SEPP 65 Design Assessment

Address of project : 78-90 Old Canterbury Road Lewisham	Application Type: Part 3(a)
Developer: Demian Constructions	Architect : Tony Owen Ptnrs
Reviewer : Russell Olsson, SEPP 65 Design Review Panellist, Parramatta City Council & North Sydney Council Design Excellence Panellist	Date of Assessment : November 2010

FIGURE 1

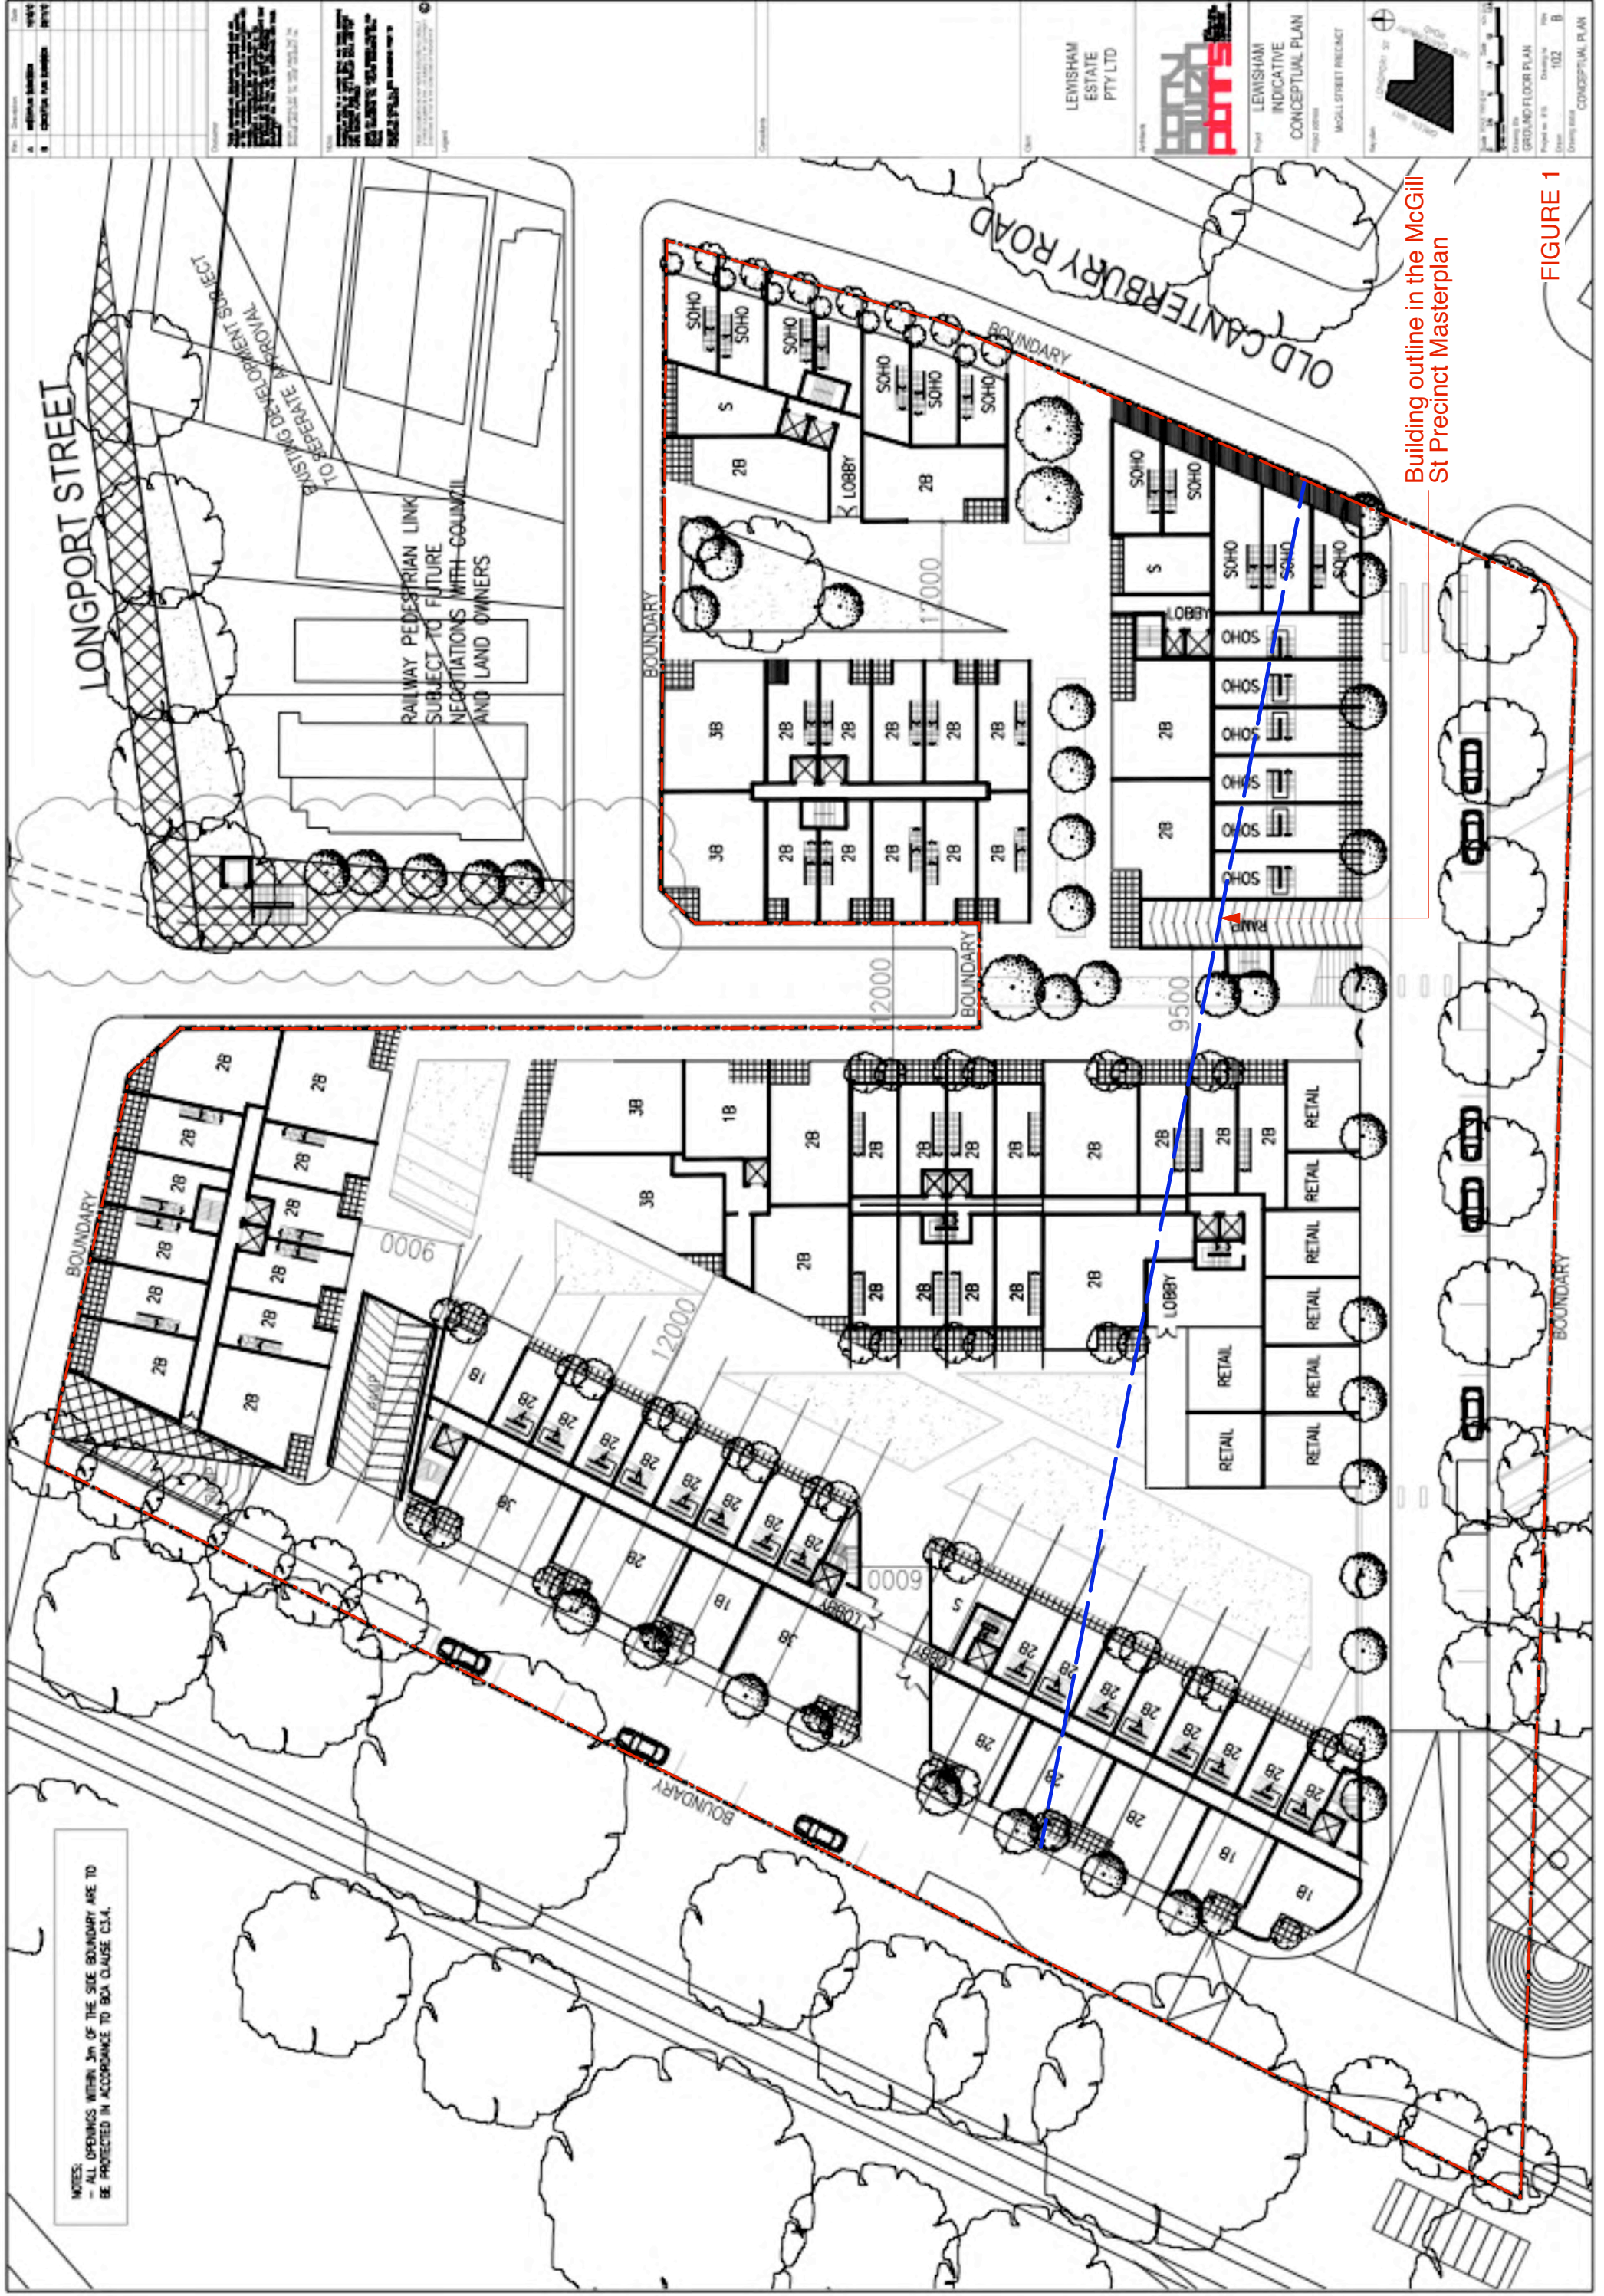
1. The spatial definition of the New Local Park
 2. The building alignment along the New Local Park is between 27m and 6m forward of the building alignment in the McGill Street Precinct Masterplan (Fig. 1)

2. The southern building alignment along the New Local Park is between 27m and 6m forward of the building alignment in the Marrickville Council Masterplan. This has substantial implications for the provision of deep soil on the site (see Principle 5 Resource , Energy and Water efficiency).

- The encroachment by buildings into the area of the New Local Park by up to 28m (Fig. 1)
 - The 2800 sqm underground supermarket and specialty shops, totalling 5914 sqm, which the McGill Street Precinct Masterplan does not contain.
 - The increased building heights of 8 storeys instead of 6 storeys on Block D; 9 storeys instead of 4 storeys on the southern end of Block A; 6 storeys instead of 4 storeys on the southern and northern ends of Block C
 - The increased building depths in Blocks D and F from max. 20m to 23m and in Block C from max. 20m to 24m
-
- The encroachment of Block E into the view shaft of the south extension of Browne Street
 - The close proximity of the southern end of Block F to Block E. In terms of built form and solar access to and outlook from Block E, Block F should be a minimum of 12m from Block E

It is recommended that the amount of deep soil in the New Local Park is doubled, to achieve 25% of the total open space on site. It is recommended that its width is doubled, to an average of 12m. If the access street along the northern side of the New Local Park is retained in its current form and width, the building alignment north of that street should be set back a minimum of 6m to the north from the alignment proposed in the current DA. This new alignment will not reduce below ground car parking, as the parking can extend under the street, which it does not do in the current proposal.

FIGURES 2 & 3

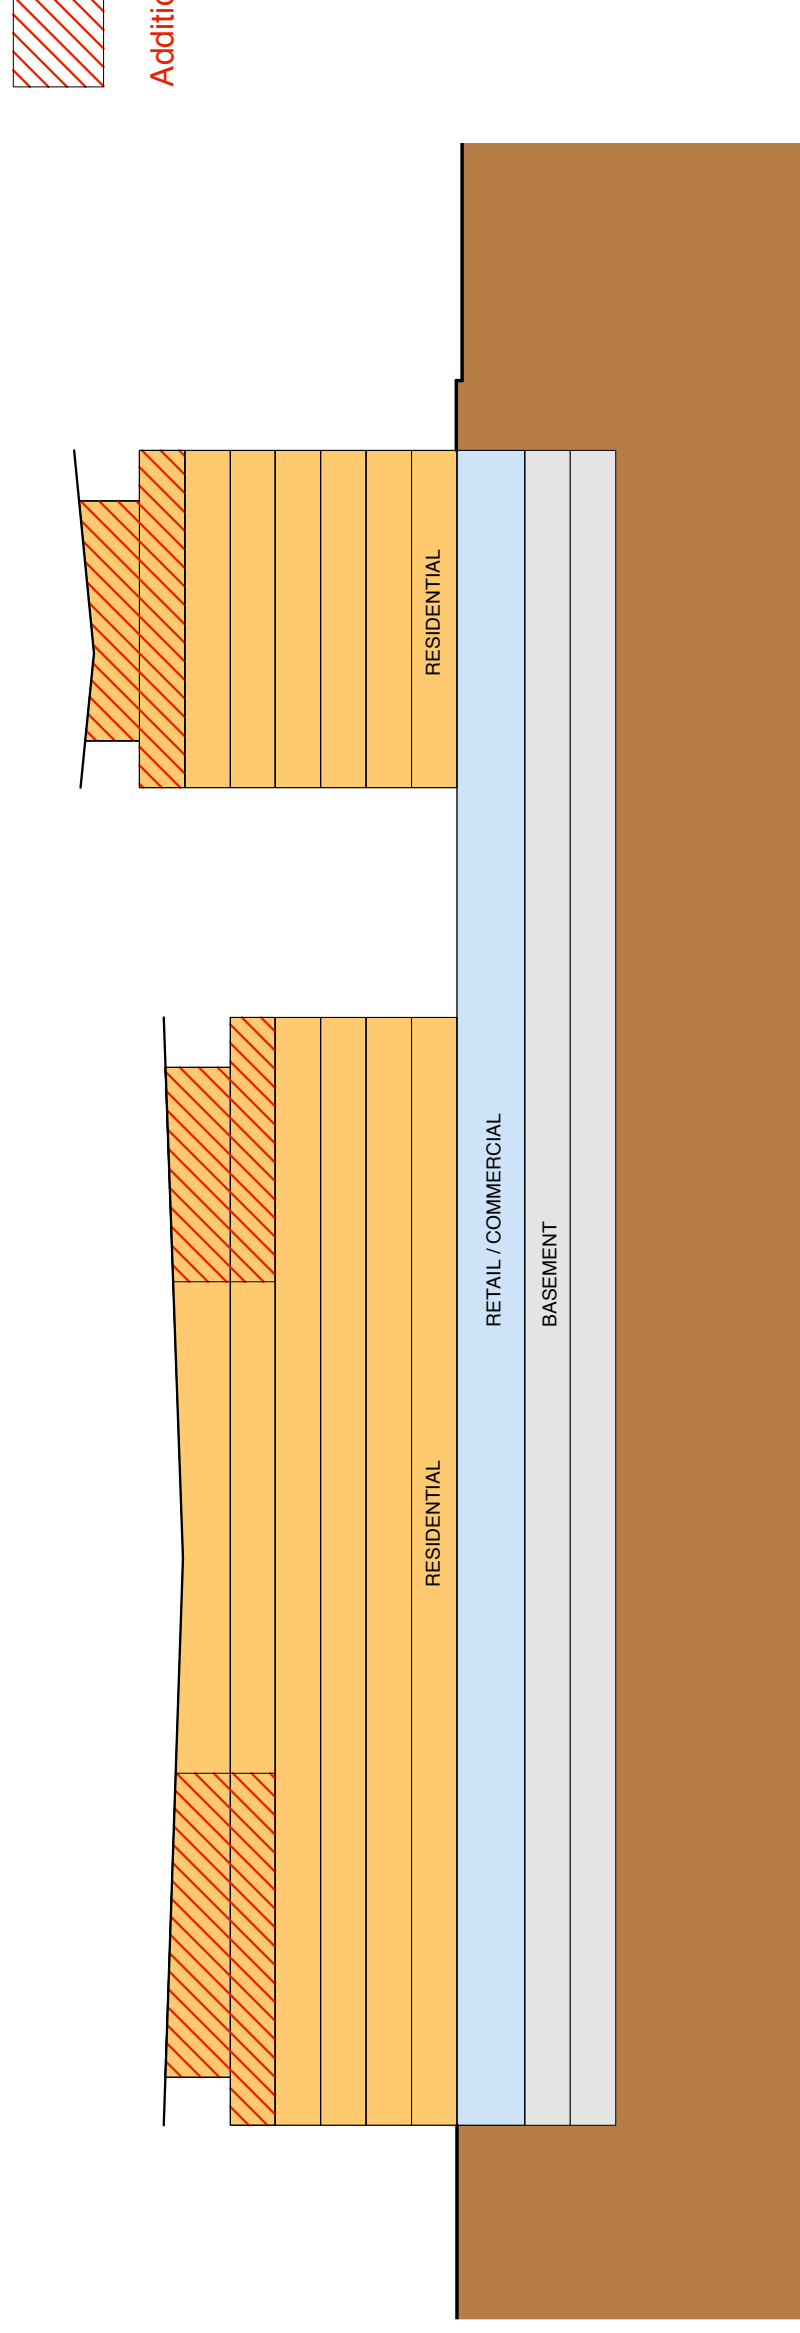
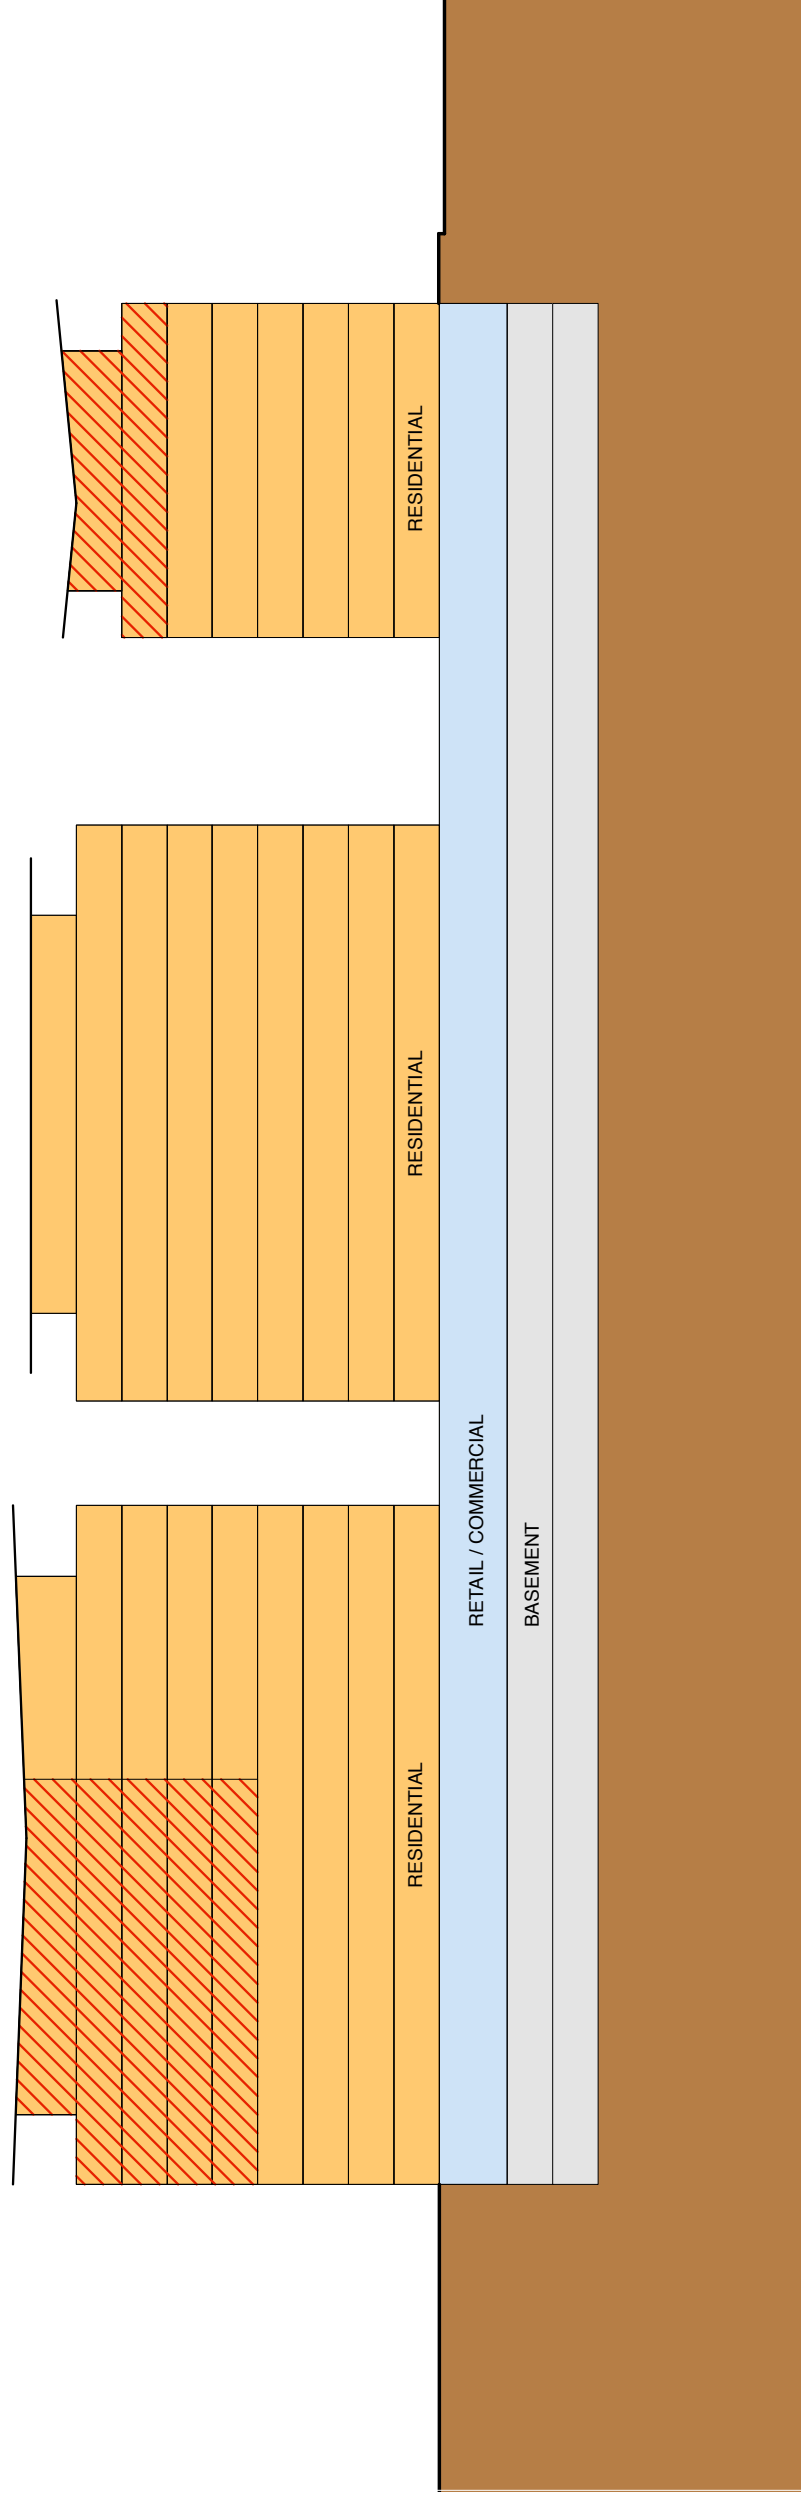
3. The traffic and truck servicing pattern
 4. The building heights are increased in Block A from 4 storeys to 8/9 storeys; In Block D from 6 storeys to 8 storeys; in Block C, from 4 to 6 storeys in the southern end and the northern end (remaining the same in the middle) (Figs. 2 and 3)

5. Gaps are introduced between buildings at corners of blocks (Figs. 2 and 3)
 6. A supermarket and 18 specialty shops are added underground.
 7. Encroachments are made into the southern extension of the Browne Street view shaft and Block F is too close to Block E. In terms of built form and solar access to and outlook from Block E, Block F should be a minimum of 12m from Block E

4. Building height increases are proposed in Blocks A, C and D. The proposed 8 storeys on the southern end of Block A is excessive, in particular because the steep ramp of the truck turning circle at the base of the building will expose the supermarket wall, effectively making the building 9 storeys when viewed from the Light Rail station. The 8 storeys overshadows the New Local Park. The building should be reduced to 6 storeys, to reduce overshadowing of the New Local Park, and to create a consistent 6 storey building height along the northern edge of the park. This consistent height of 6 storeys is greater than the 4 storeys proposed in the McGill Street Precinct Masterplan, however the width of the space would be great enough (if the buildings were set back 6m as described above) to make this an acceptable built form to open space proportion. A 6 storey building would further overshadow the space, and for that reason it is strongly recommended that the 6th floor should be set back a minimum of 6m to reduce the overshadowing and to create a roof scape design to this row of buildings.

The height increase of 6 to 8 storeys in Block D is excessive, as this part of the site is most visible from the surrounding area, along Longport Street and generally along Railway Terrace and Carlton Crescent, to the east and west of the site. An 8 storey building on this site would create an undesirable precedent for the development of the corner site at the intersection of Longport and Old Canterbury Road, which is currently 4 and 6 storeys. It is recommended that the height remain at 6 storeys above the basement retail below ground.

5. Gaps are introduced between buildings at corners of blocks (Figs. 2 and 3). These gaps decrease the FSR, however they create a better internal environment for buildings at corners, particularly acutely angled corners. The McGill Street Precinct Masterplan avoided acutely angled internal corners by having a rectangular courtyard and splayed buildings. This approach would have been acceptable if the residential buildings were multi-lift cored buildings. Due to the extensive retail below ground, multiple cores were impractical. Fewer cores linked by straight corridors in residential buildings were proposed. Those buildings are most efficient when rectangular in shape, hence the (generally) rectangular buildings and irregular courtyard. Acutely angled corners are avoided with gaps between buildings. This is acceptable practice.
